# HALLMAN GROVE (7-06004)

Re: Hallman Grove Subdivision  
 Application #7-06004  
 North Potomac, MD

**HALLMAN GROVE SUBDIVISION  
COMMUNITY DENSITY ANALYSIS  
10 AUGUST 2005**

PRE-APPLICATION CONCEPT PLAN  
**HALLMAN GROVE**  
 CONCEPTUAL LAYOUT #4  
 MONTGOMERY COUNTY, MARYLAND

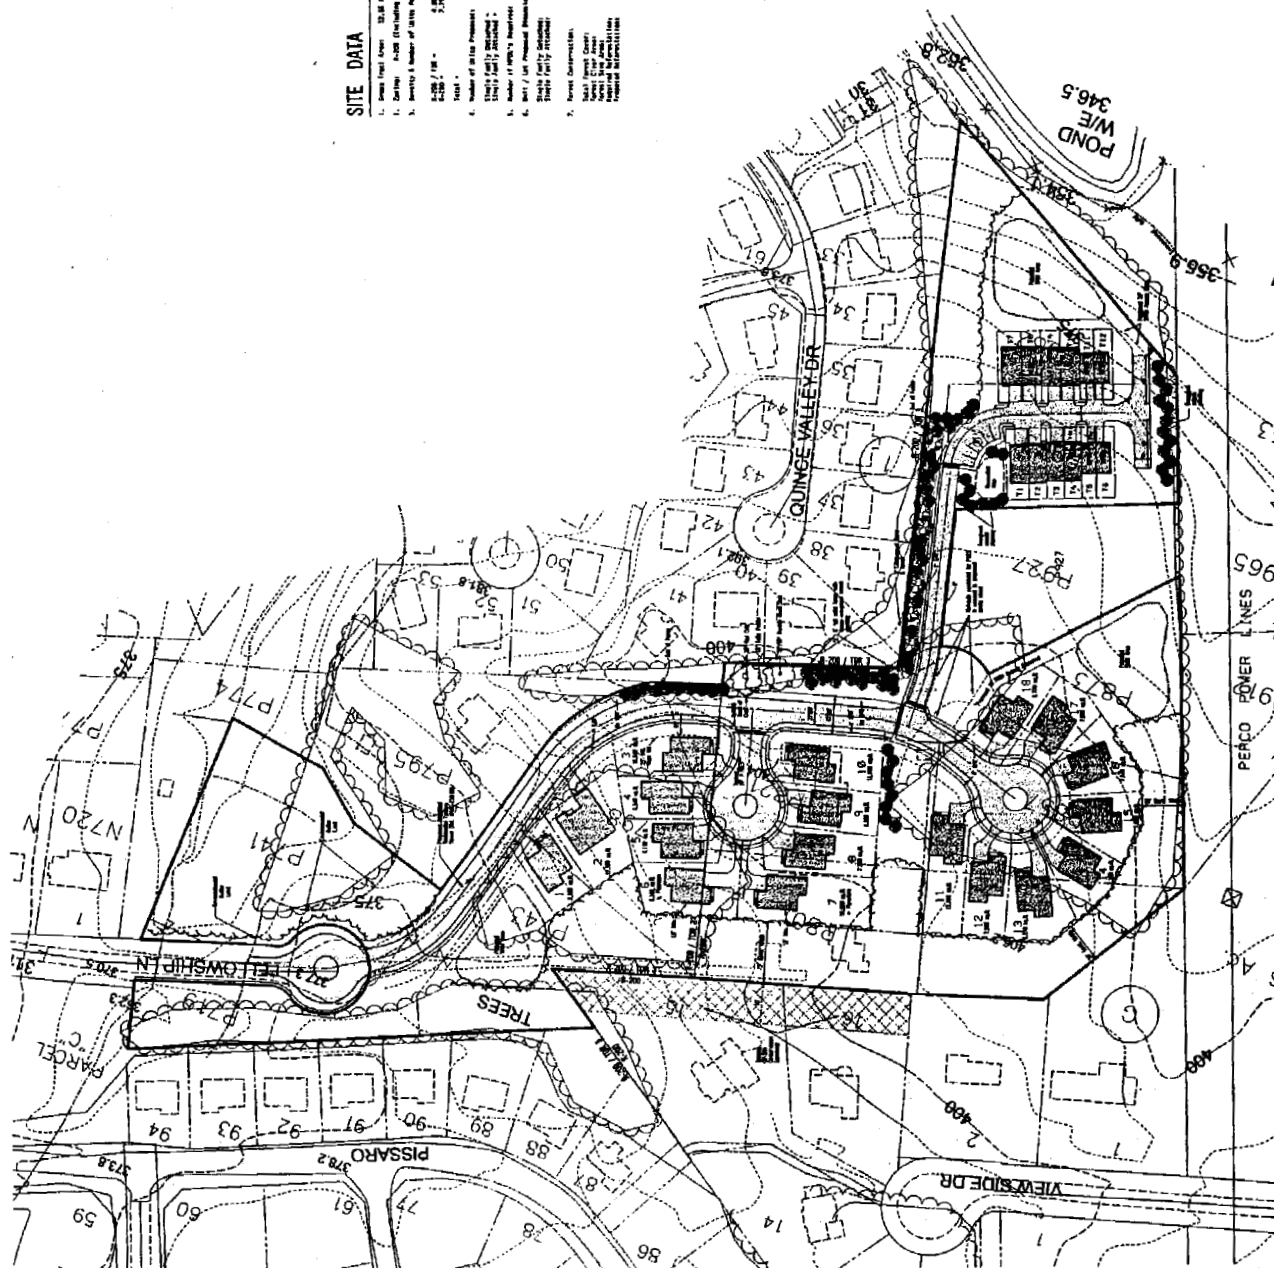
We are writing in opposition to the Hallman Grove Subdivision as currently proposed. The developer is proposing a cluster development with thirty dwelling units on a 12.65 acre parcel. The current zoning on this property is a combination of R-200 and R-200 TDR-3. We understand the property owner's right to develop the land, but feel very strongly that the proposed development must be consistent with the density that could be achieved within the existing zoning. Cluster development concepts are intended to encourage the provision of green space and buffers around development. This is achieved by clustering the housing with reduced setbacks, etc. On this site, the developer is attempting to use the cluster development concept to increase the project's density by including land in the density calculation which cannot be developed.

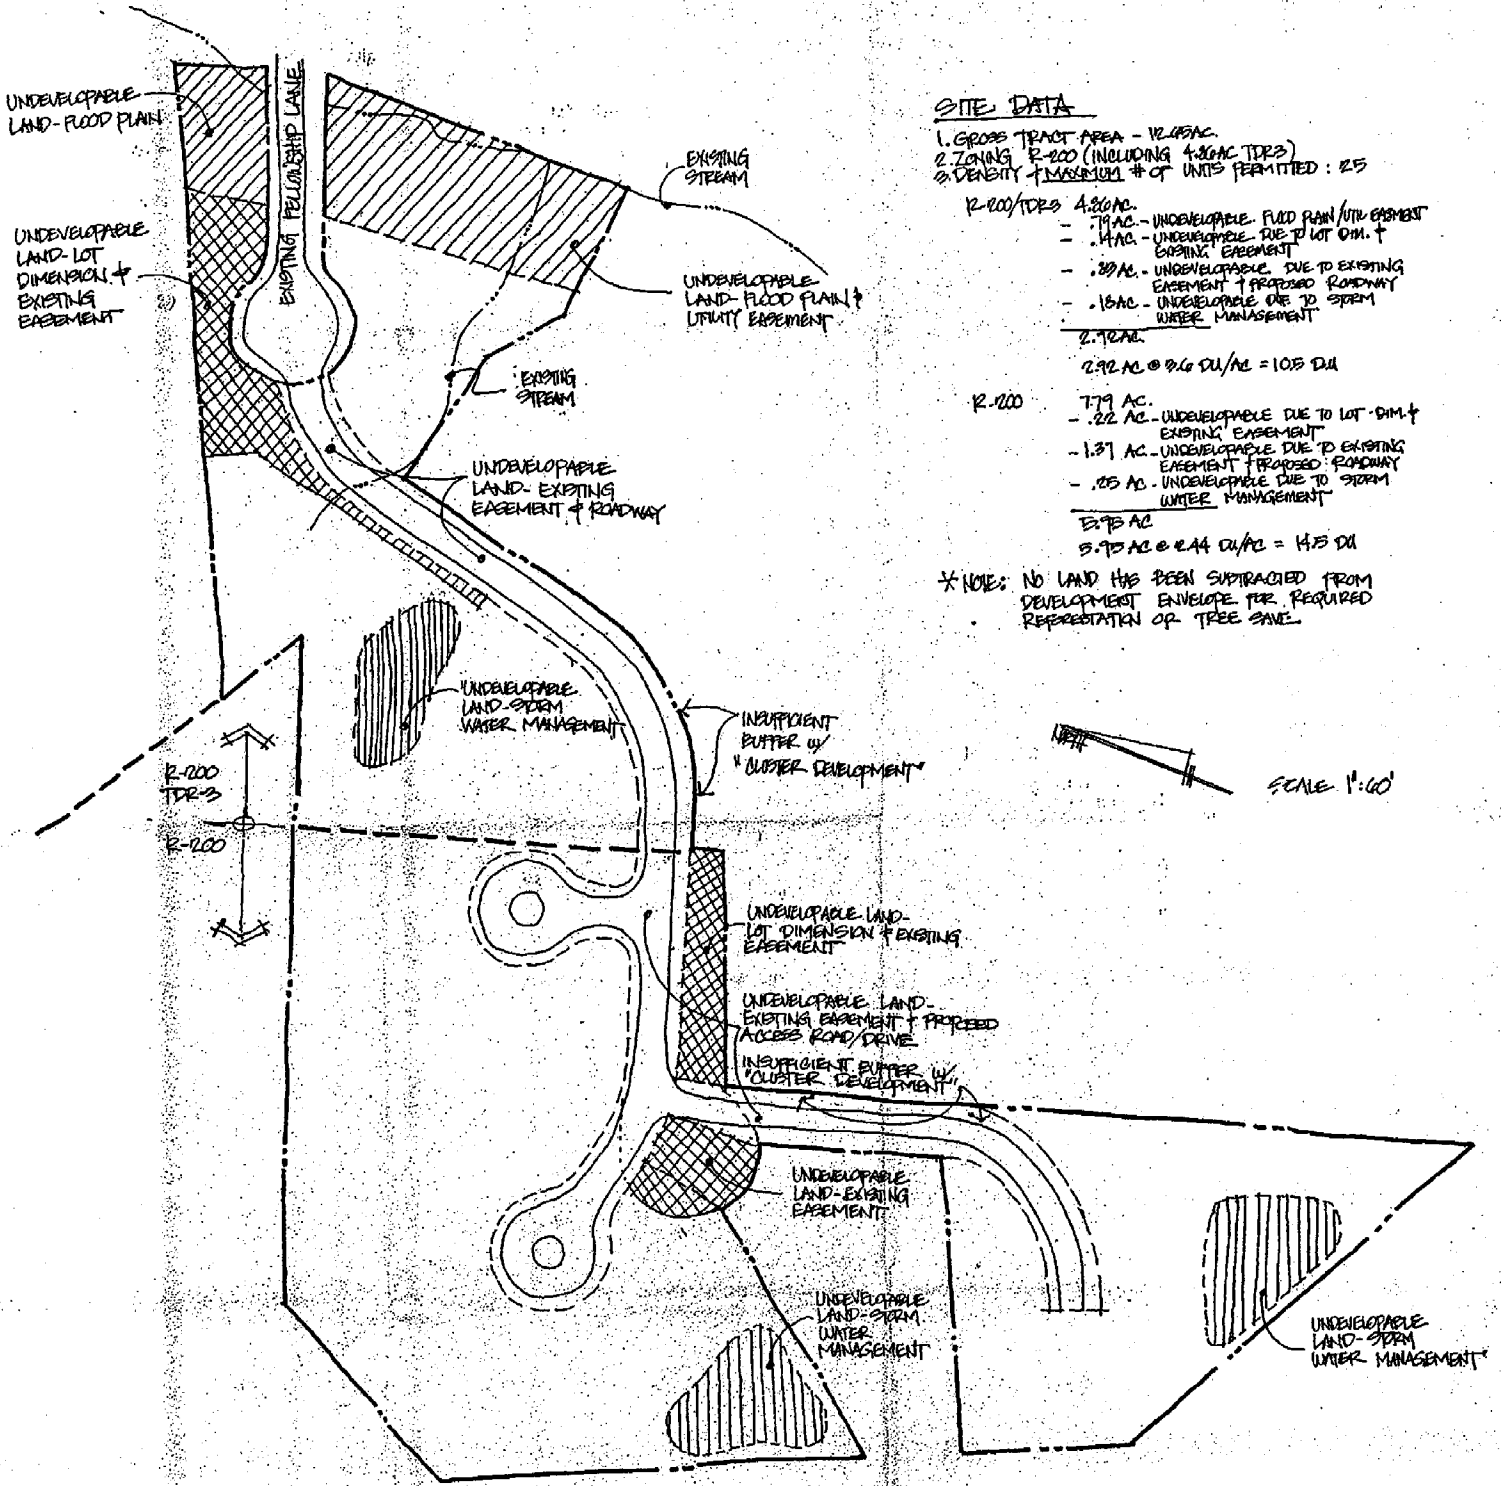
We have prepared the attached drawing and density calculations to highlight areas that must be subtracted from the total lot area to determine the maximum number of units that can be developed on this site. As you can see from our analysis, the developer has overstated the allowable density on the property by at least 11 dwelling units. Given the odd geometry of the tract of land and the many restrictions to development, we do not believe that more than 22 dwelling units could be developed without the implementation of a cluster concept. Further, the proposed development does not satisfy one of the key requirements of a cluster concept – the provision of additional buffers and green space for the community. Little or no buffer has been provided for the homes in Quince Orchard Estates which will back up to the proposed access road for the development.

- 1. GROSS TRACT AREA - 12.45 AC.
  - 2. ZONING R-200 (INCLUDING 4.80 AC TRS)
  - 3. DENSITY & MAXIMUM # OF UNITS PERMITTED : 25
- R-200/TRS 4.80 AC.
- .71 AC - UNDEVELOPABLE - FLOOD PLAIN/UTL EASEMENT
  - .41 AC - UNDEVELOPABLE - DUE TO LOT DIM. & EXISTING EASEMENT
  - .39 AC - UNDEVELOPABLE - DUE TO EXISTING EASEMENT & PROPOSED ROADWAY
  - .18 AC - UNDEVELOPABLE - DUE TO STORM WATER MANAGEMENT
- 2.72 AC
- 2.92 AC @ 9.6 DU/AC = 105 DU
- R-200
- 7.79 AC.
- .22 AC - UNDEVELOPABLE - DUE TO LOT DIM. & EXISTING EASEMENT
  - 1.37 AC - UNDEVELOPABLE - DUE TO EXISTING EASEMENT & PROPOSED ROADWAY
  - .25 AC - UNDEVELOPABLE - DUE TO STORM WATER MANAGEMENT
- 6.15 AC
- 5.95 AC @ 4.4 DU/AC = 45 DU

\* NOTE: NO LAND HAS BEEN SUBTRACTED FROM DEVELOPMENT ENVELOPE FOR REQUIRED REPLANTATION OF TREE SAME.
